MILLSTONE NUCLEAR POWER STATION, UNIT NO. 1
PROPOSED REVISIONS TO TECHNICAL SPECIFICATIONS

JULY, 1980

NORTHEAST NUCLEAR ENERGY COMPANY

MILLSTONE NUCLEAR POWER STATION, UNIT NO. 2

Figure 6.2-1 Offsite Organization for Facility Management and Technical Support

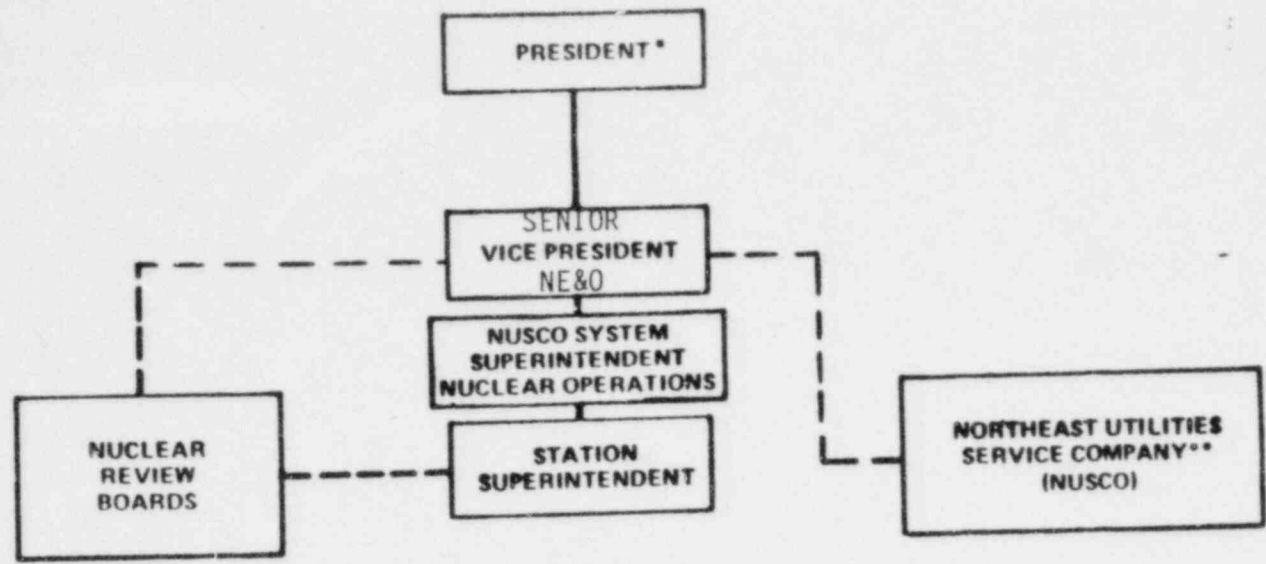
PROPOSED REVISIONS TO TECHNICAL SPECIFICATIONS
